**TO: PLANNING COMMISSION**

**SUBJECT: APPEAL OF PLANNING ADMINISTRATOR'S DECISION APPROVING TENTATIVE SUBDIVISION / CLASS 2 ZONING ADJUSTMENT PERMIT CASE NO. 21-05 FOR PROPERTY LOCATED AT 2230 DOAKS FERRY ROAD - 97304**

Should the Planning Commission affirm, modify, or reverse the Planning Administrator's approval of a Tentative Subdivision and Class 2 Zoning Adjustment for Case No. SUB-ADJ-21-05 to allow a 27 lot subdivision with an alternative street standard to allow the grade of Buzz Street to exceed 12%, exceed the 600-foot maximum block length and to reduce the street width from 60-feet to 50-feet and a Class 2 Adjustments to exceed the maximum lot width to depth of 300 percent to 500 percent for Lot 12 and to allow Lot 3 to reduce the minimum lot depth for a double frontage lot from 120 feet to 112 feet, for property approximately nine acres in size and zoned RA (Residential Agriculture).

### LOT GRADING & TREE CONSERVATION PLAN

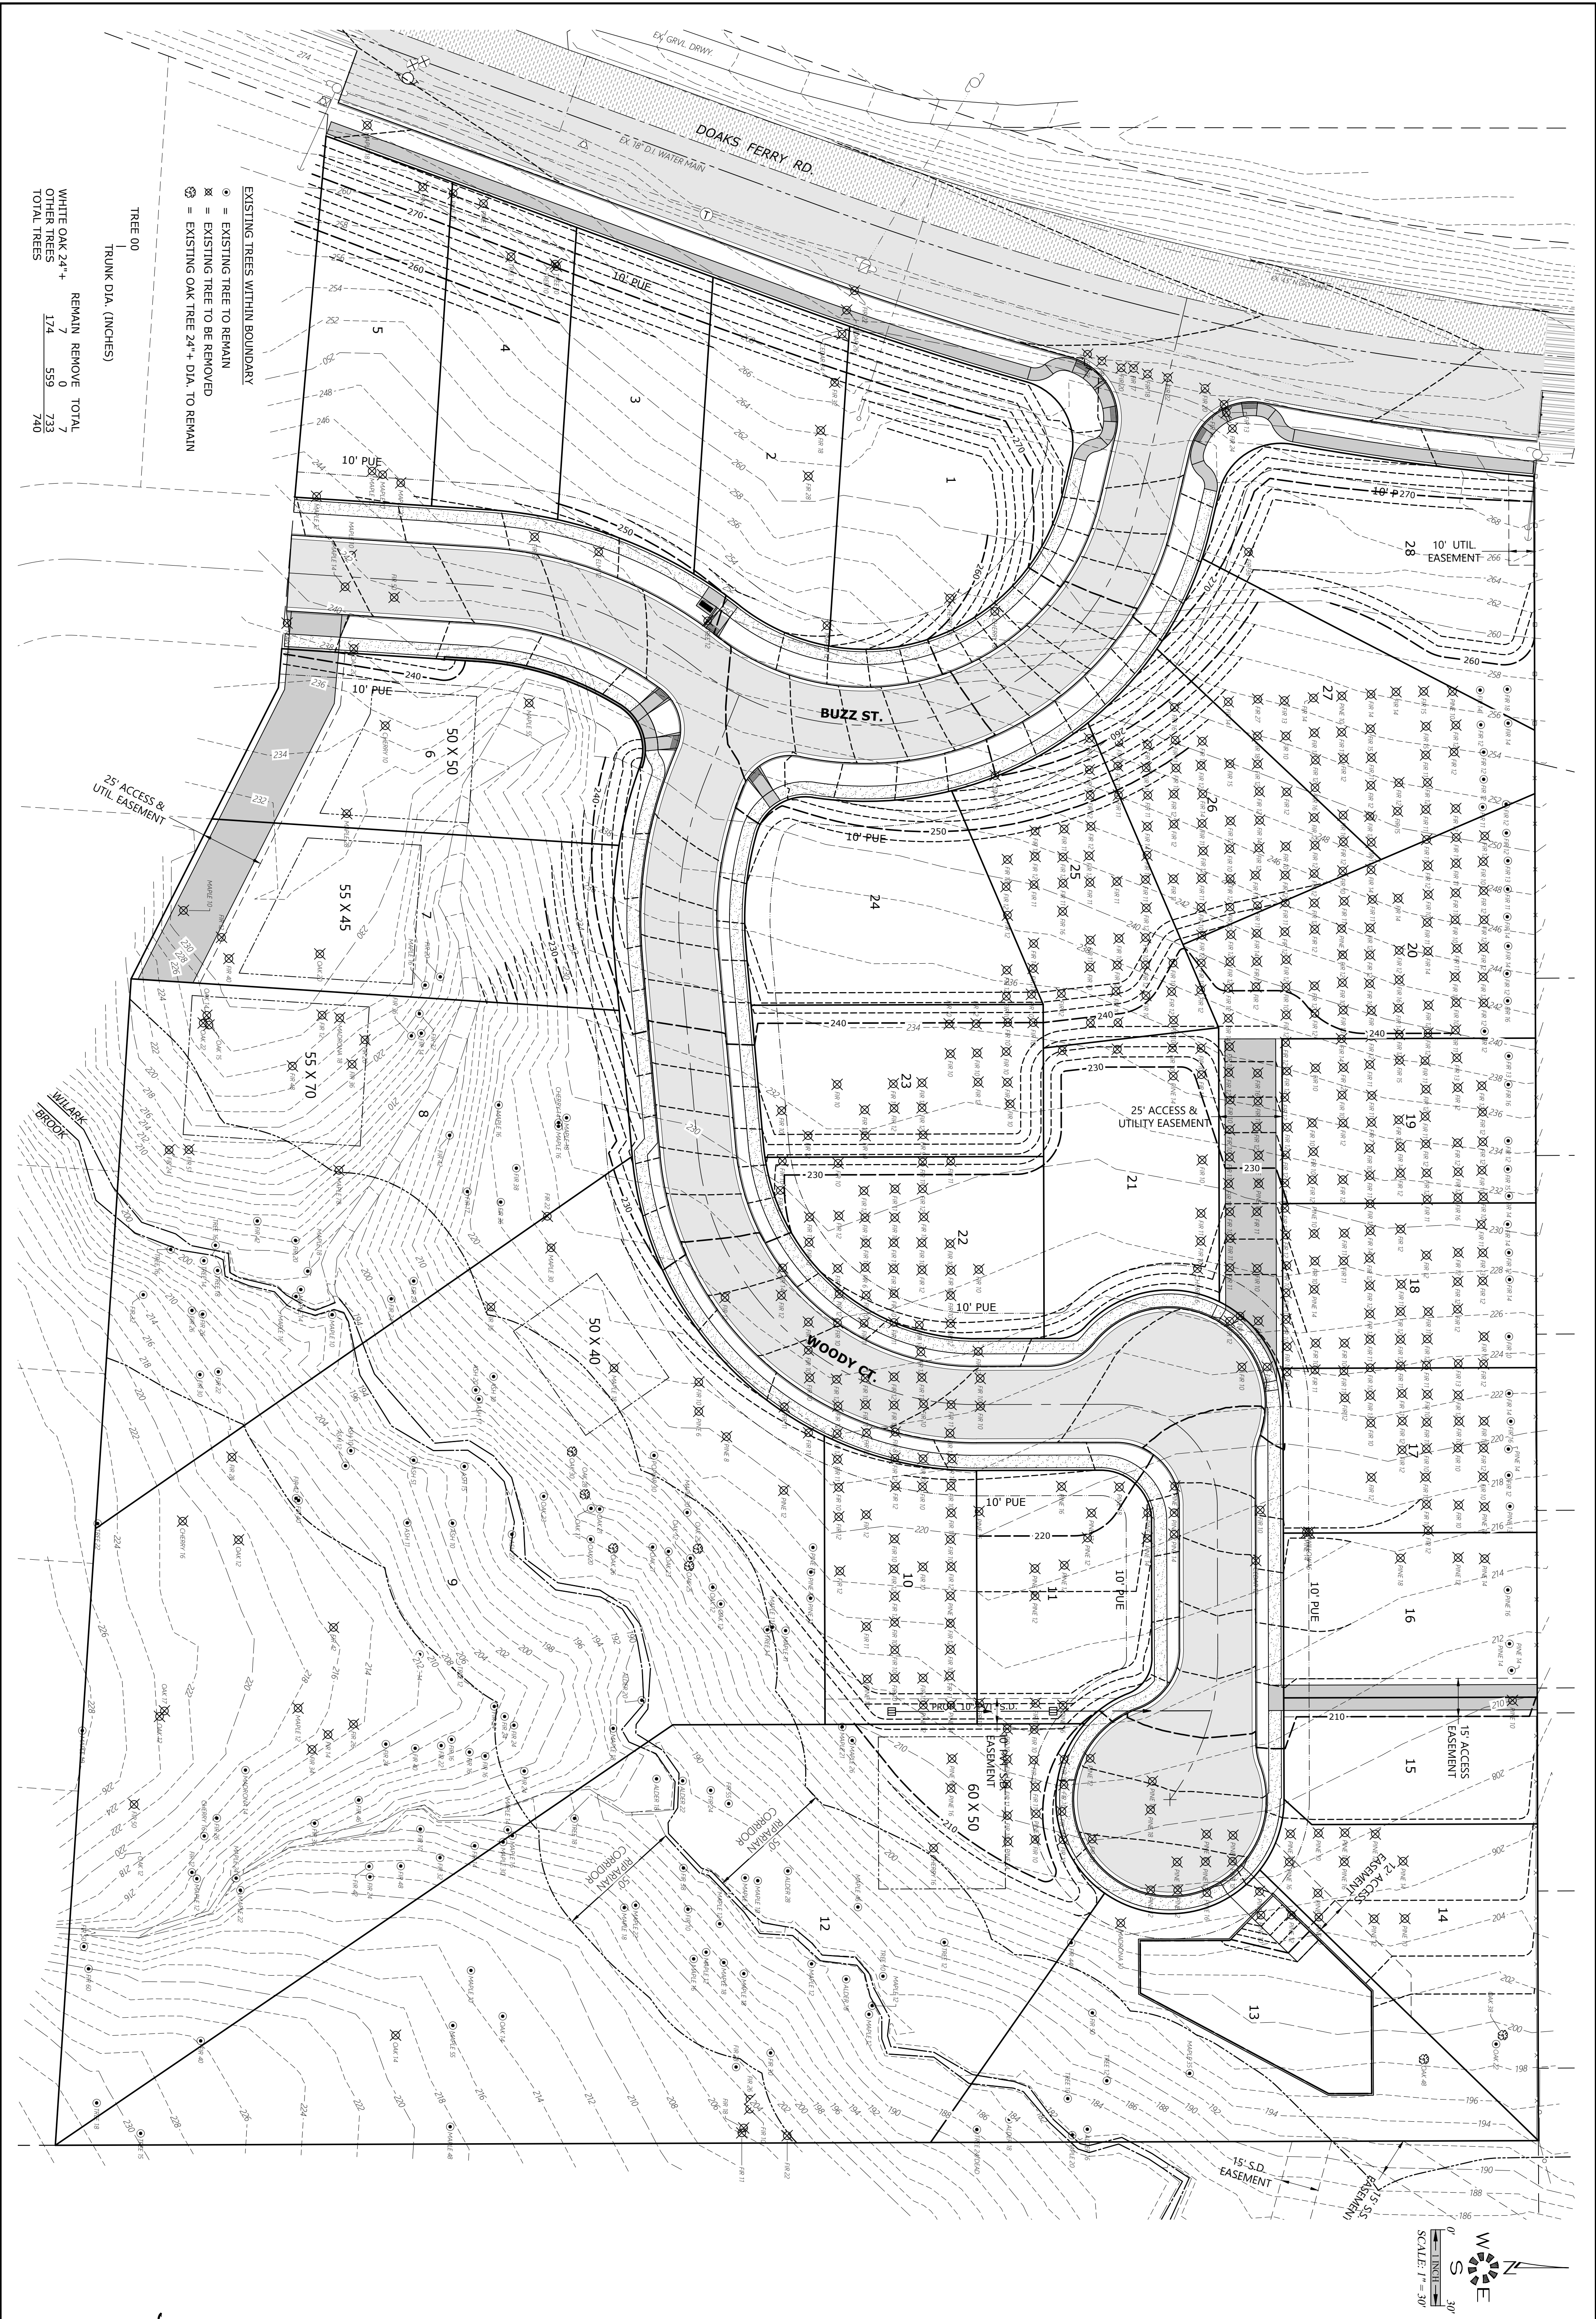
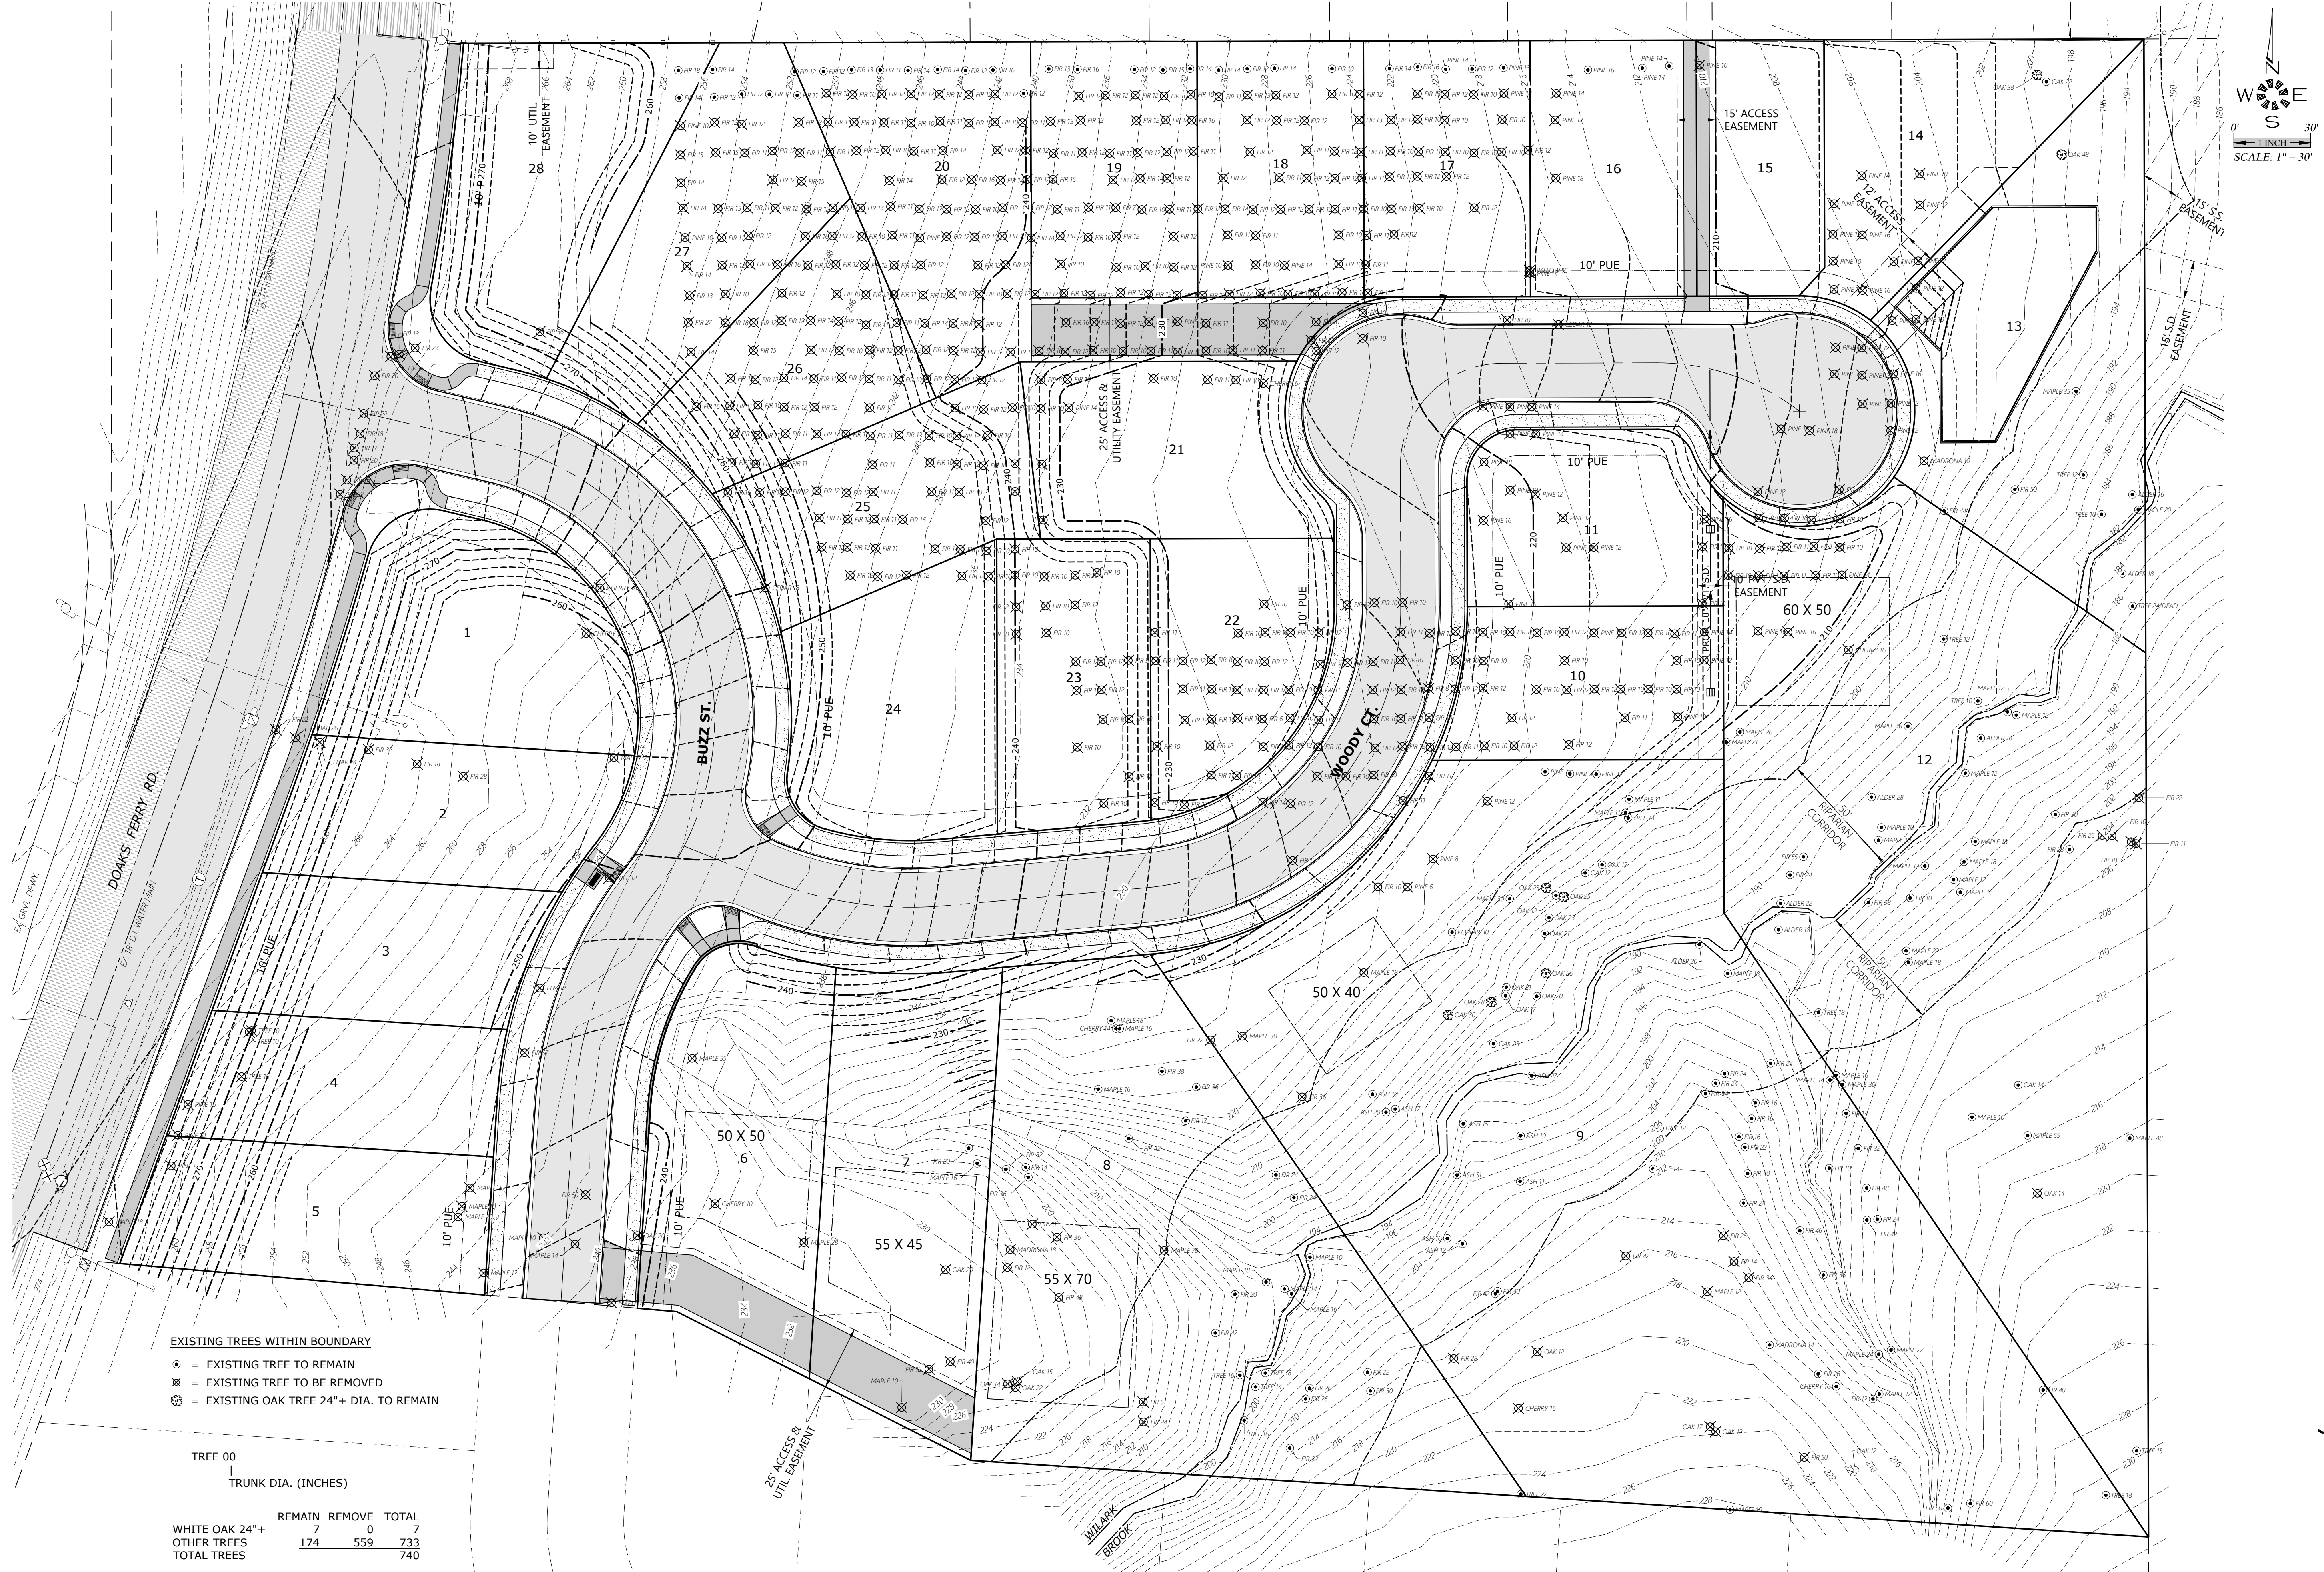
- Condition 9:** The trees designated for removal on the south side of Wilark Brook on Lot 9 (11 trees) and Lot 12 (six trees) shall be preserved.
- Condition 10:** Prior to issuance of building permits on Lot 8, the applicant shall plant two (2) big leaf maple (*Acer macrophyllum*) trees with a minimum 1.5" caliper, five (5) vine maple (*Acer circinatum*) with a minimum height of 24-36", and ten (10) 1-gallon sword ferns (*Polystichum munitum*). These trees and vegetation are in addition to requirements of SRC 808.050.

- Condition 11:** Any construction or grading on Lots 8, 9, 12 and 13 shall remain within the building footprints shown on the tentative subdivision plan.

- Condition 16:** Grading within the 50-foot riparian area shall not occur under the drip line of any tree designated for preservation. Grading plans shall provide fencing and protection for all native vegetation and trees, including under the drip line.

**Condition 17:** No trees or native vegetation within the riparian zone shall be removed through a Tree Conservation Plan Adjustment. Any future removal shall only be authorized through an approved Tree Removal Permit (SRC 808.030).

Figure 1: Image from Salem Keizer Local Wetlands Inventory (1999)

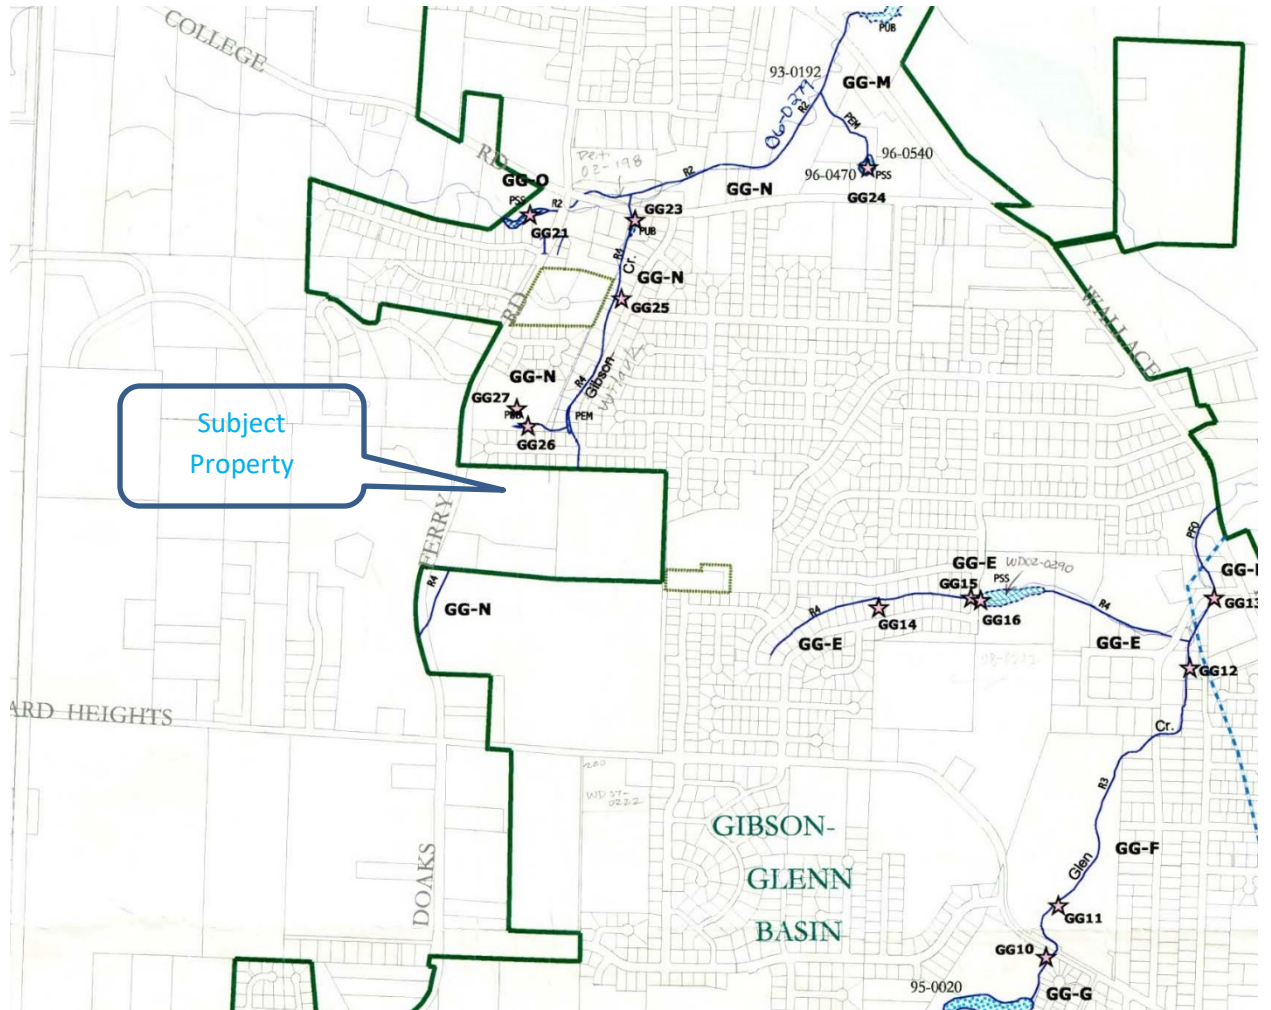
1. The application fails to identify two headwater streams tributary to Wilark Brook as required by SRC 205.030 (a) (10) and (11) *to locate waterways* (10) and SRC 250.005 (c) submittal requirements *to locate natural features including creeks*.
2. The application does not include a wetland inventory. The subject property was outside the City as shown on the Salem Keizer Local Wetland Inventory that was conducted in 1999 (Figure 1).

The approval on page 17 erroneously asserts: “The Salem-Keizer Local Wetland Inventory (LWI) does identify wetlands on the subject property.”

**This statement is in error since the subject property was not a part of the 1999 Local Wetlands Inventory (Figure 1).**

**Staff Response:** The subject property was located outside City limits when the City's local wetland inventory was generated in 1999. For properties annexed after 1999, City staff refer to the National Wetland Inventory and best available information to determine whether notification is warranted to the Oregon Department of State Lands. Notification was submitted to DSL for the proposed development, and DSL responded with a recommendation to perform a wetland delineation. This process complies with the approval criteria in SRC 205.010(d).

Figure 4: Map showing Tributary A

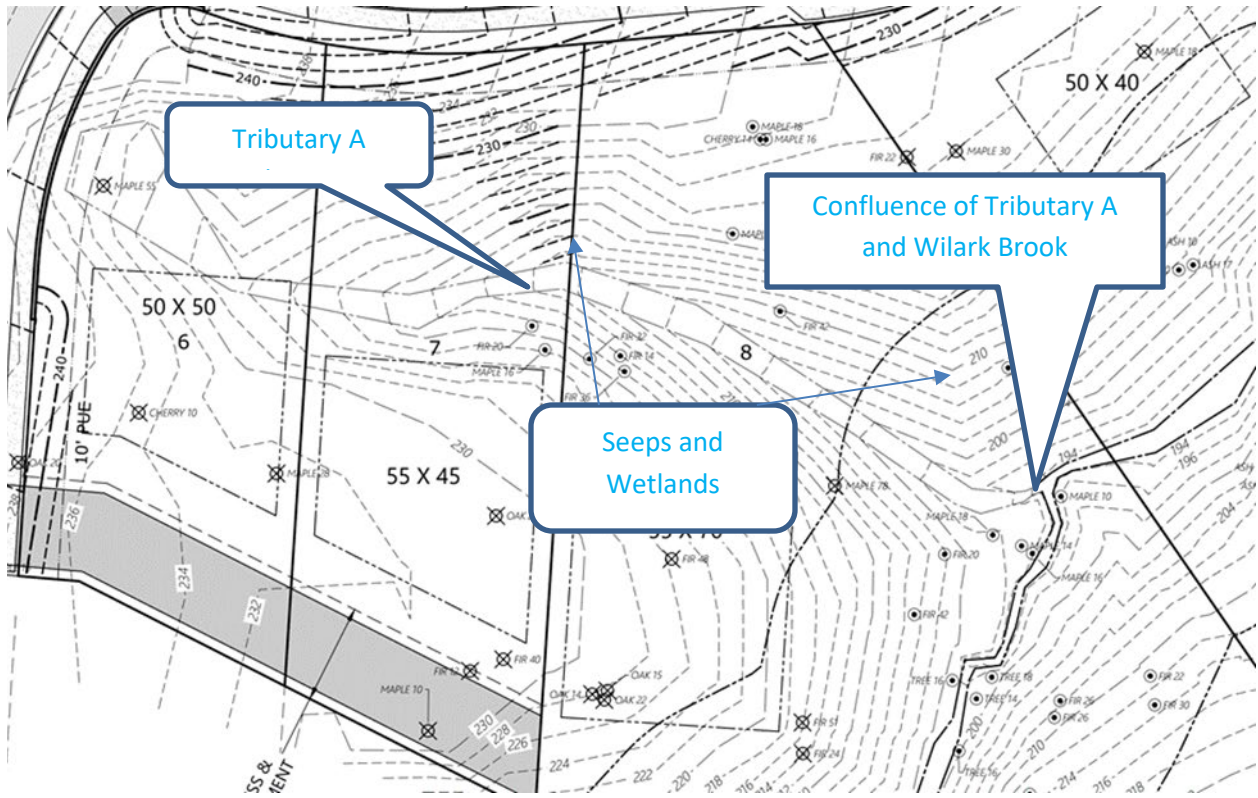
These two existing streams are not identified in the application. The designation of these streams and their 50-foot riparian corridors should be identified under the provisions SRC Chapter 808 and appropriate provisions made for their protection.

As shown in the application, the building envelope of Lot 6 fully occupies the riparian corridor of Tributary Stream A and the NE corner of the envelope extends directly into the stream. The building envelopes of Lot 7 and Lot 8 occupy the riparian corridor of Tributary Stream A and nearly extend into the stream.

**Staff Response:** The application addresses the only tributary stream identified on the Local Wetland Inventory, Wilark Brook. The applicant is required to have a permit from the Department of State Land, which requires a delineation of the subject property. If the delineation identifies waterways and wetlands that would be impacted by the proposed development, they may need to redesign the subdivision to comply with state and federal permits and/or obtain a Tree Removal Permit for any additional vegetation and/or trees needed to be removed within 50-feet of delineated waterway.
